**ADDENDUM NO. 5**

**ALTERATIONS & ADDITIONS TO:  
POLICE ANNEX TRAINING CENTER  
MARKET COMMON**

Myrtle Beach, South Carolina  
January 24, 2020

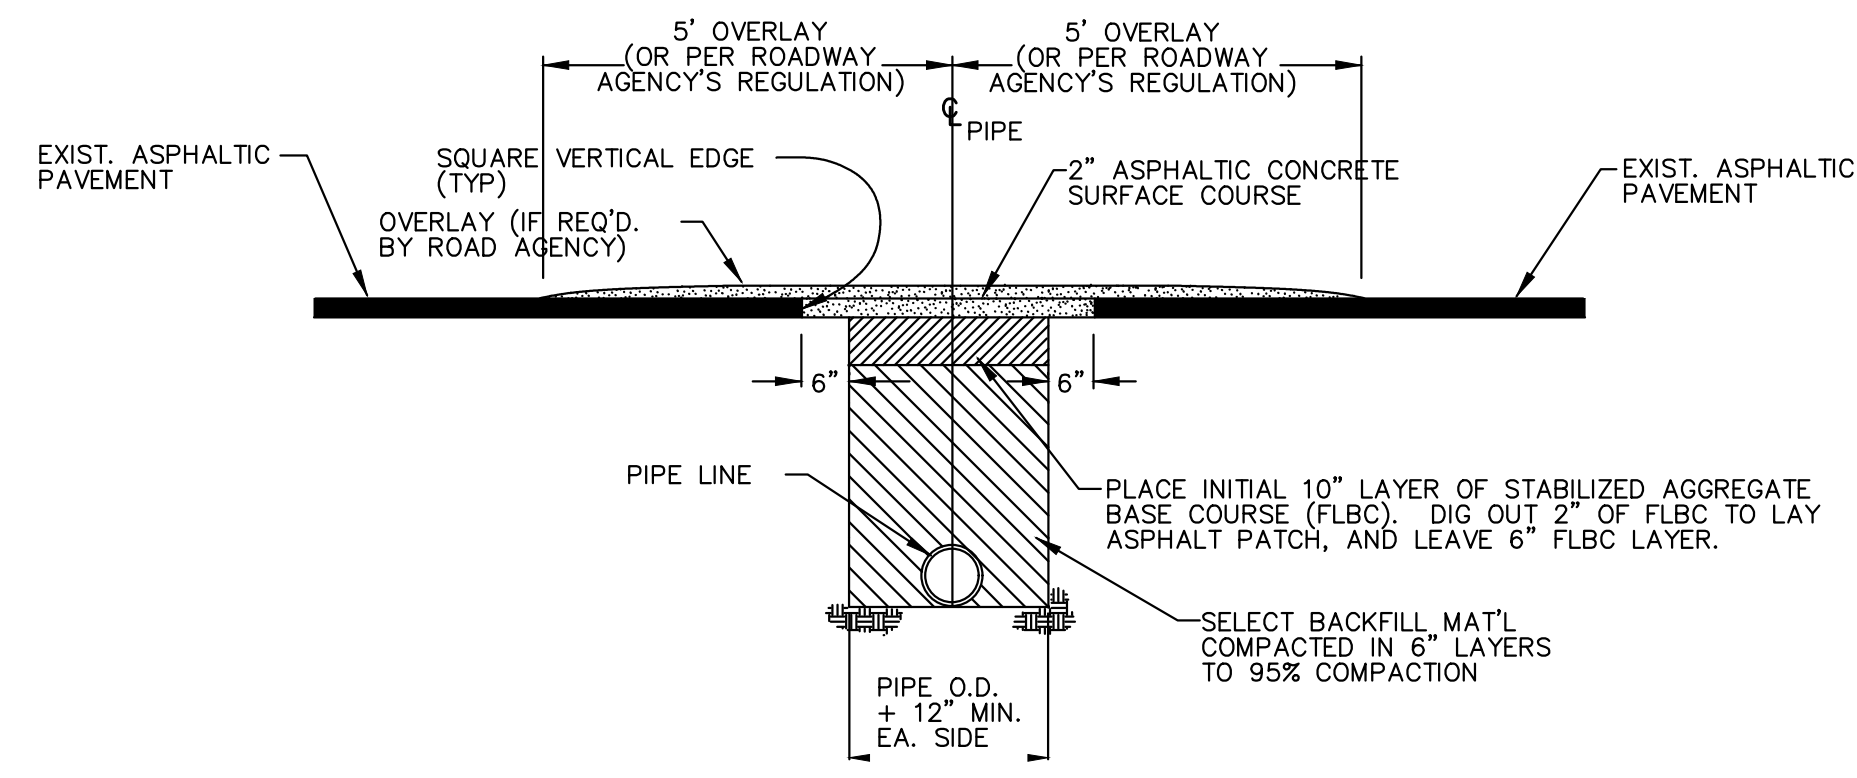
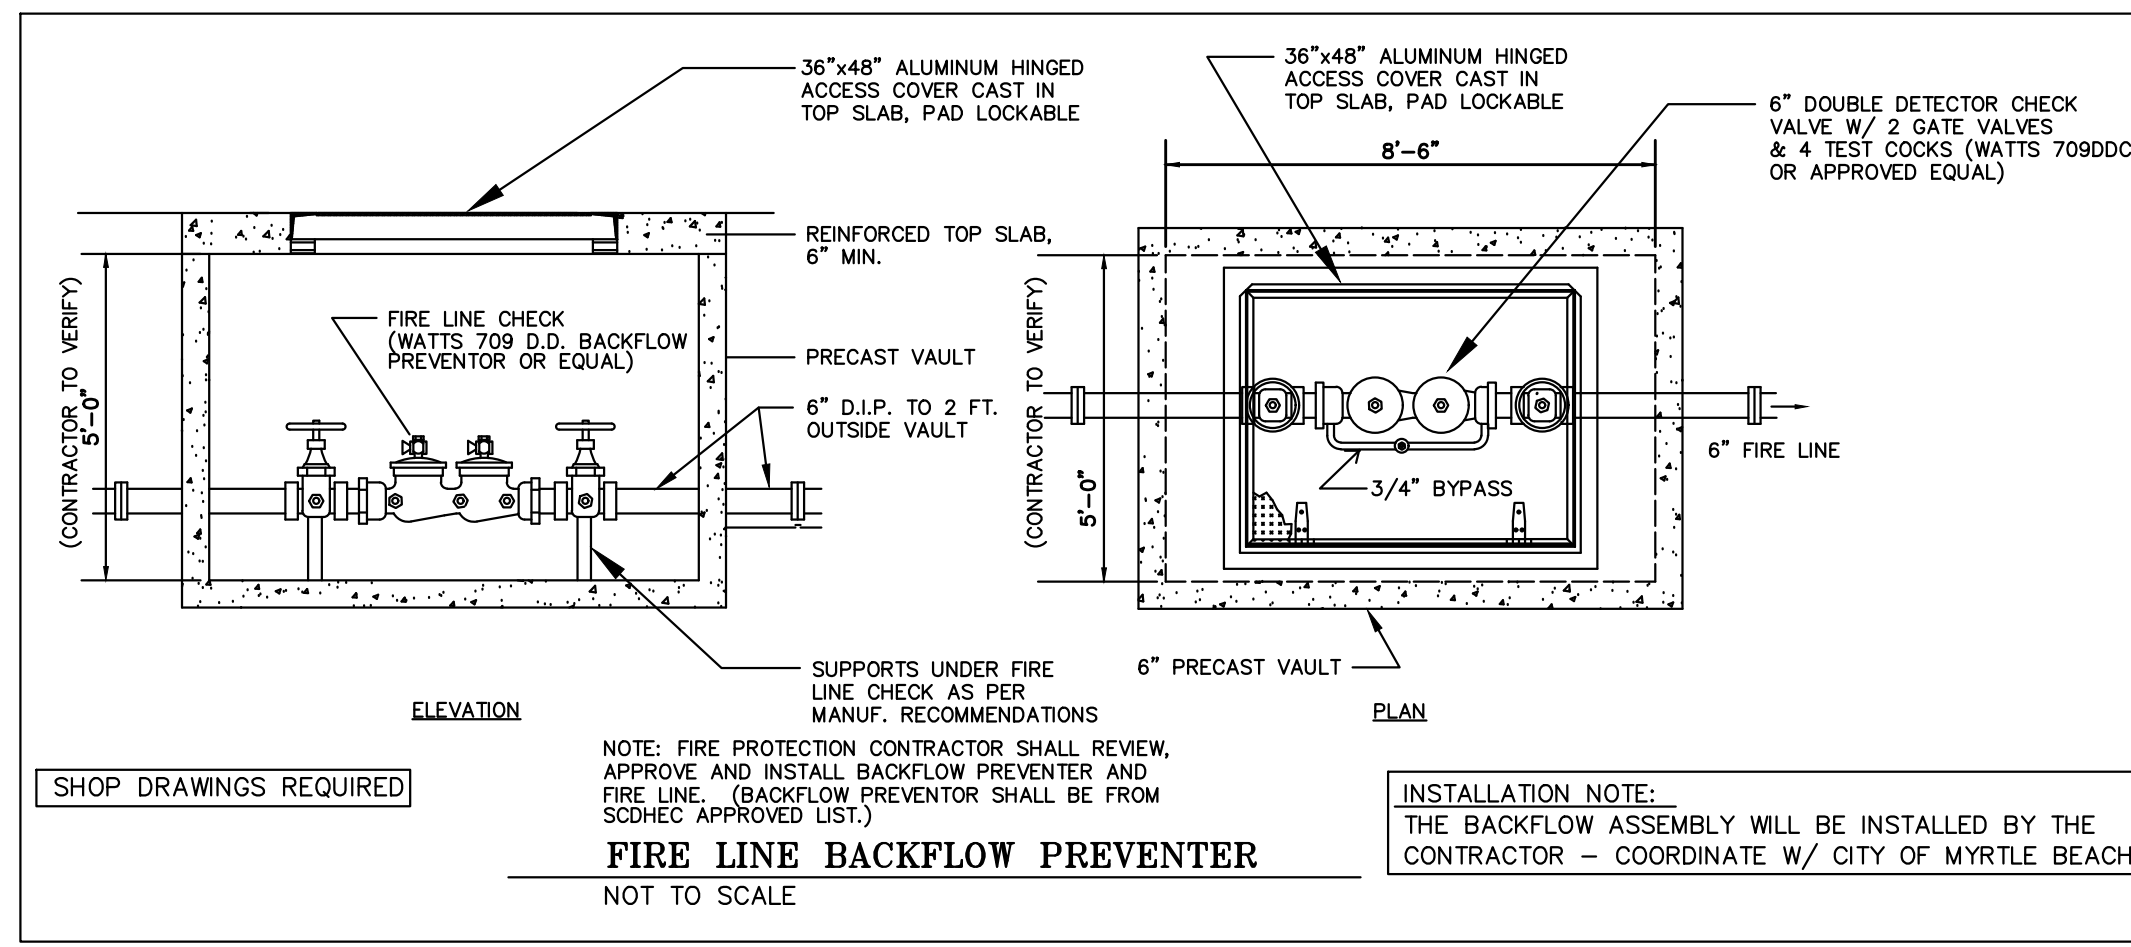
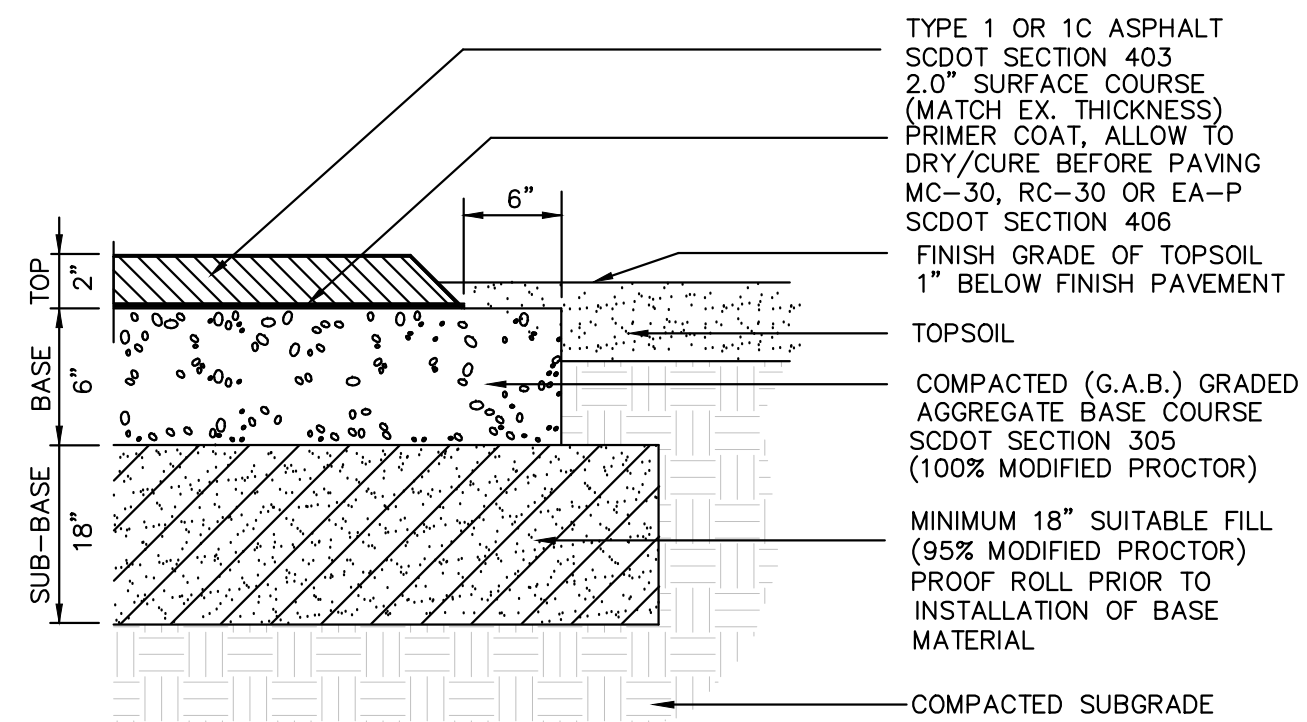
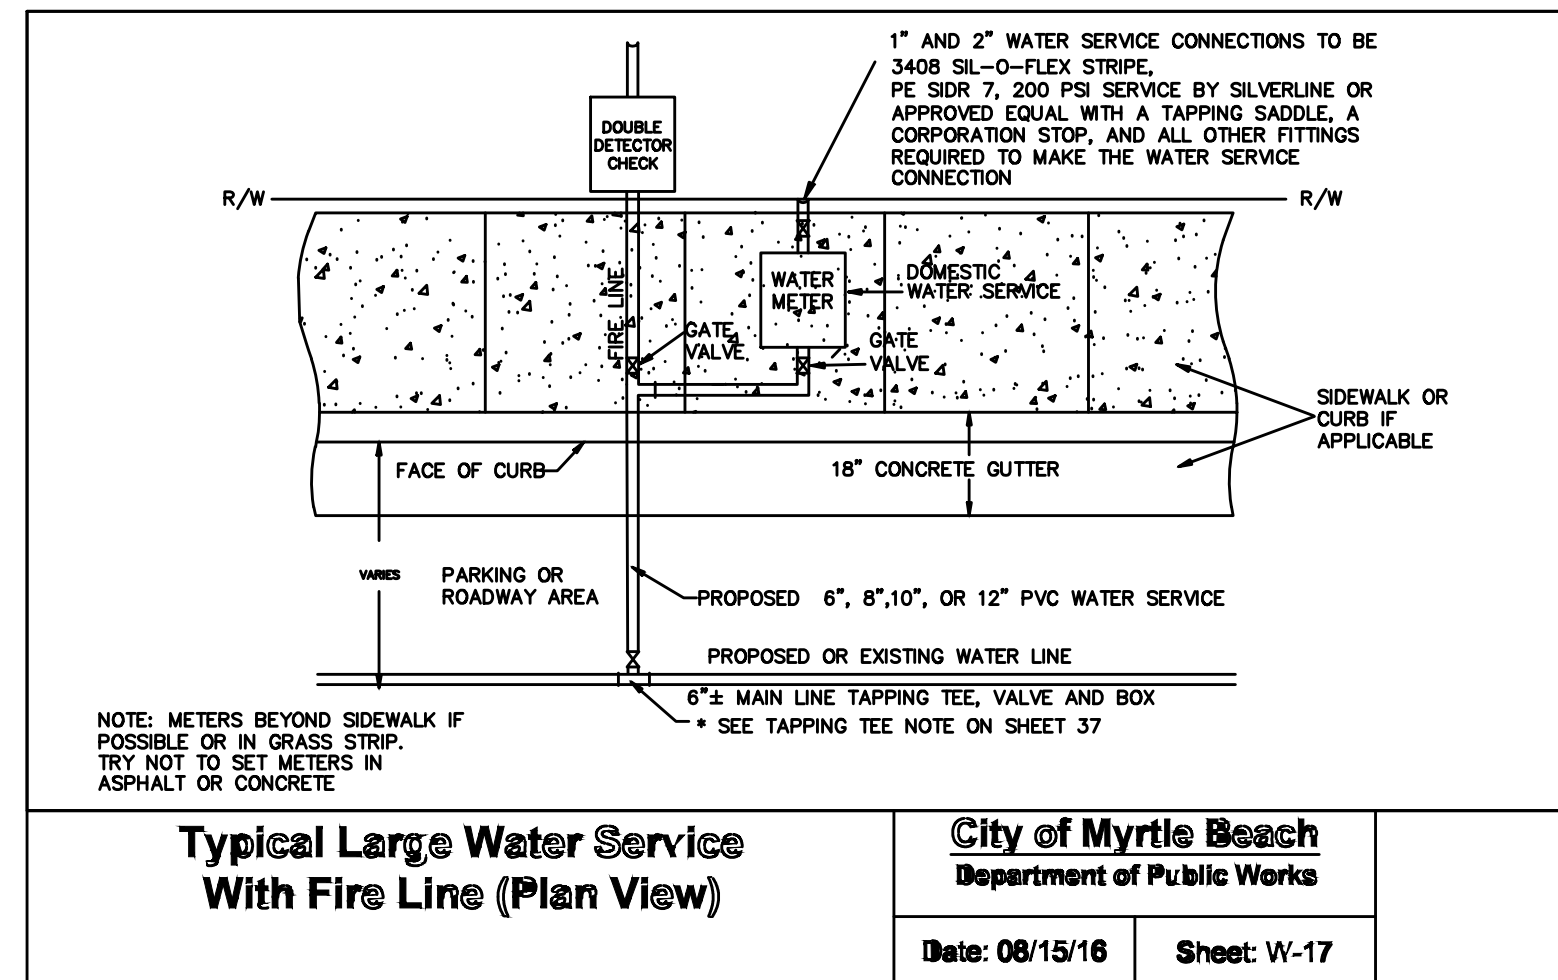
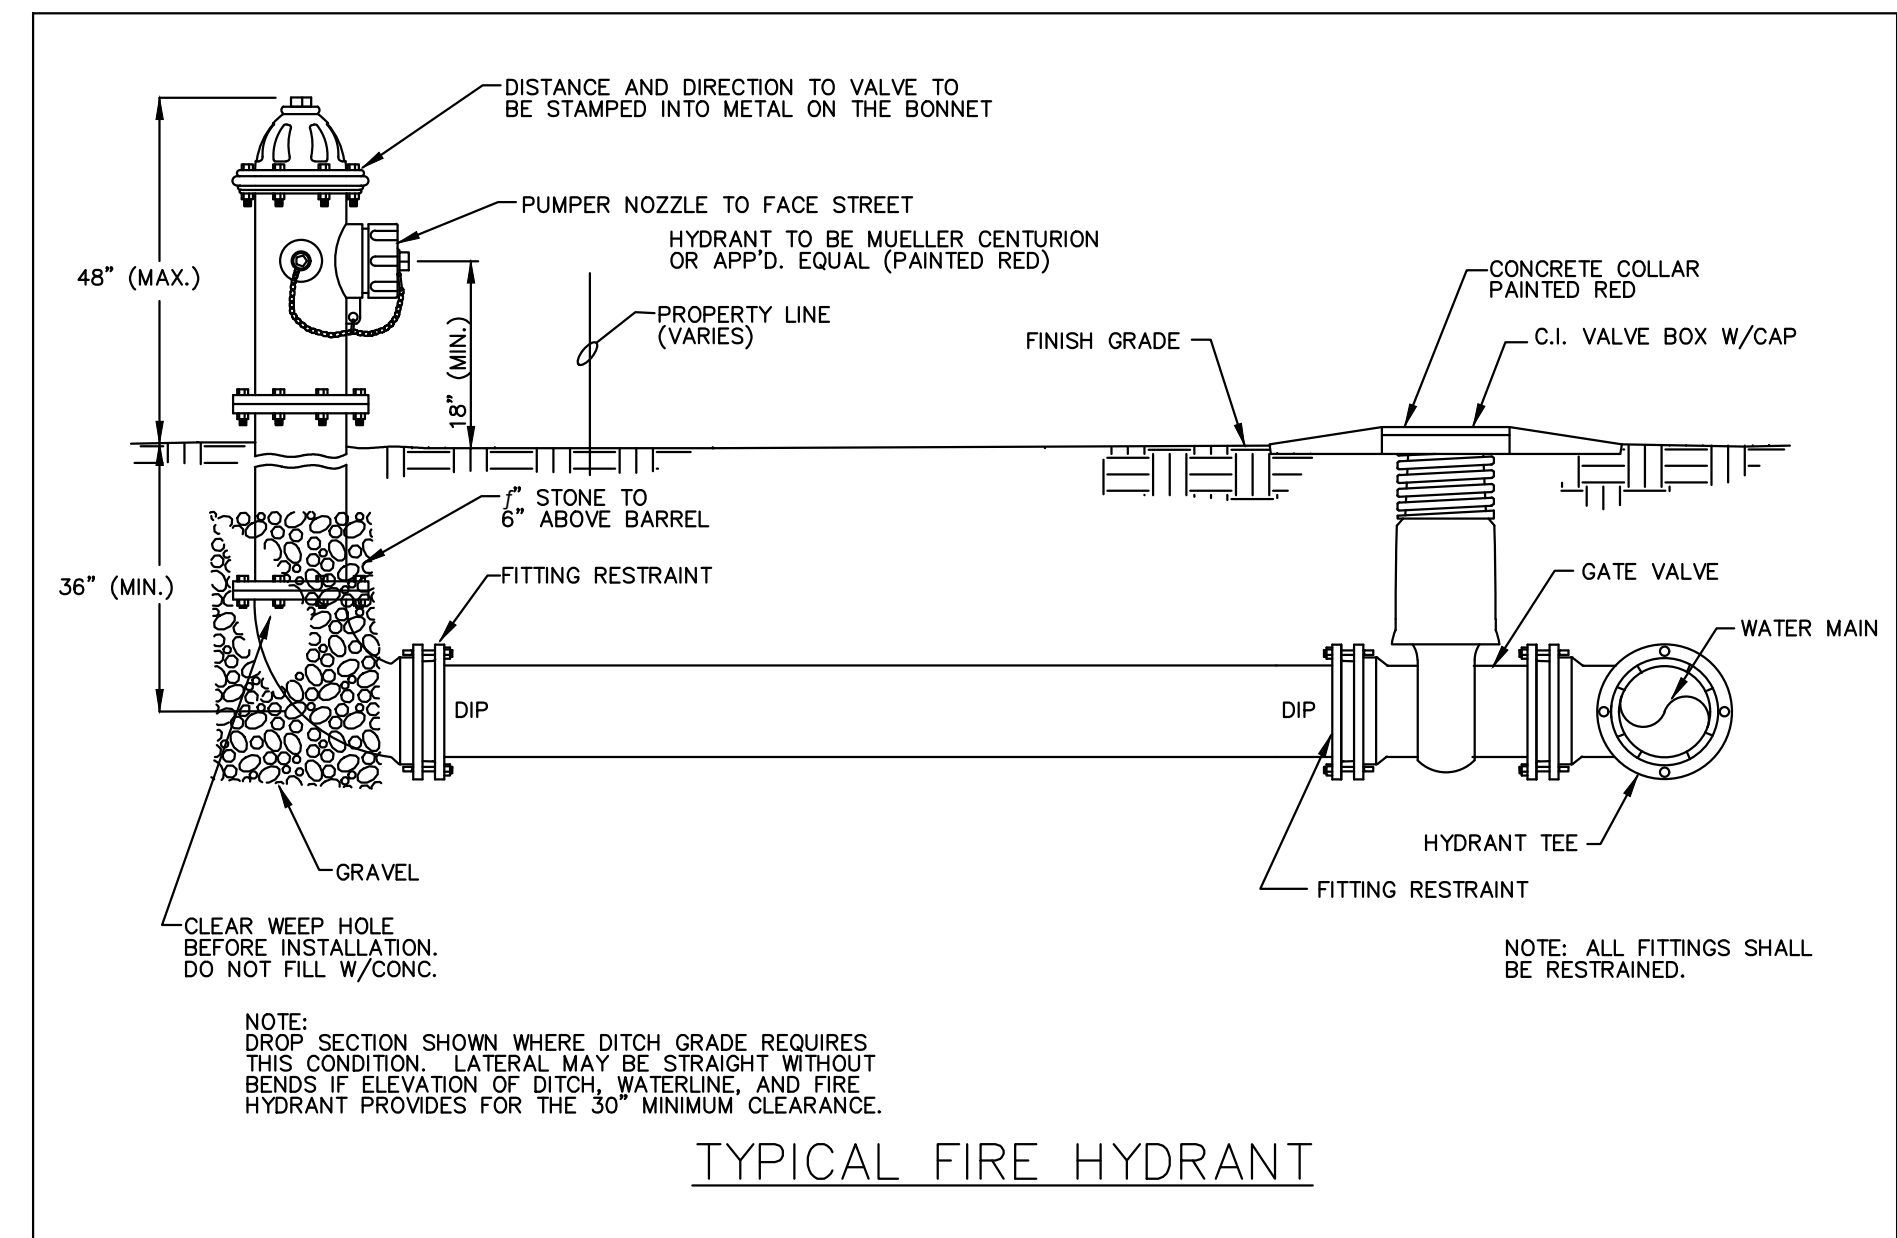
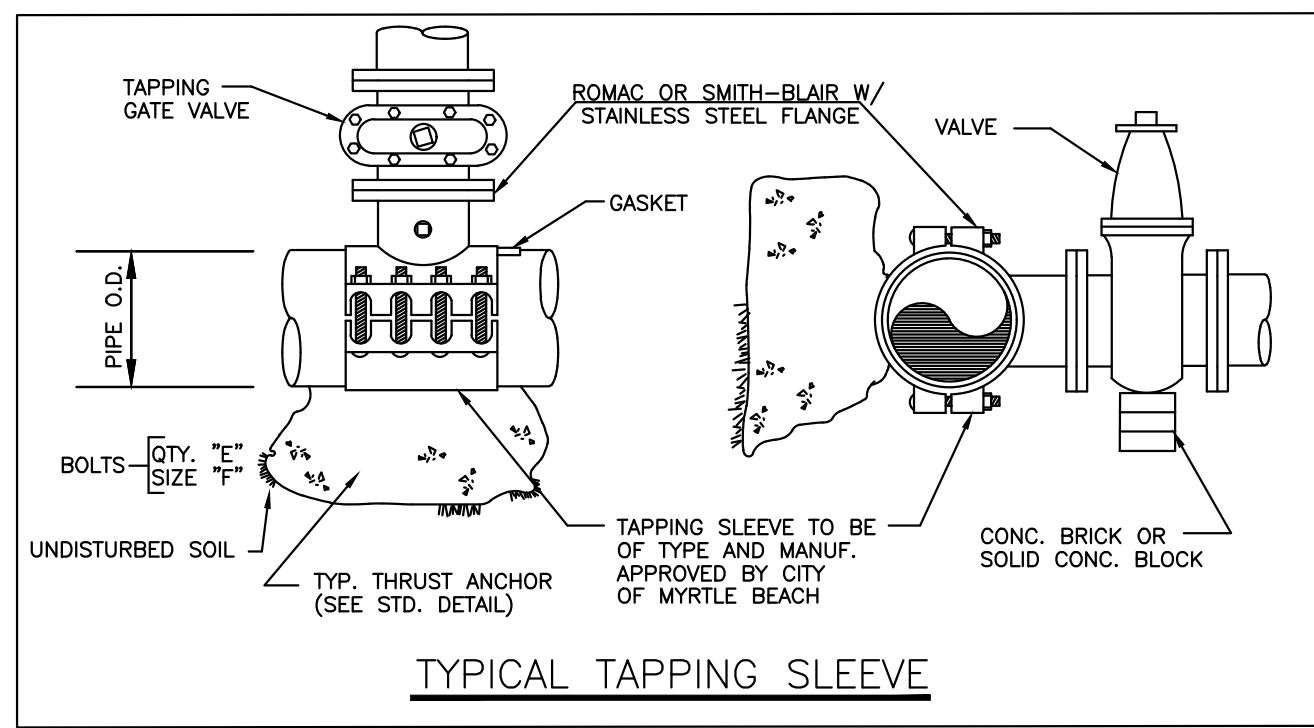
4. SHEET C6 – FIRELINE DETAILS
  - A. Contractor’s attention is directed to SHEET C6 – FIRELINE DETAILS. Contractor is advised to insert SHEET C6 – FIRELINE DETAILS (attached herewith), consisting on 1 page and dated 1/24/2020.

- A11. *Add new 8" x 6" tap (to be coordinated with the City of Myrtle Beach). Add 25 LF of a 6" pvc waterline, 1 new fire hydrant and a 6" backflow preventer (WATTS 709DDC) in a concrete vault. Add 100 LF of ductile iron fireline. Add 4" ductile iron fireline and an FDC connection. AMES Riser to be used for the piping under the building. There will be minor demolition and replacing of asphalt and curbing in order to install the new fireline. See attached revised drawings C5 and C6.*
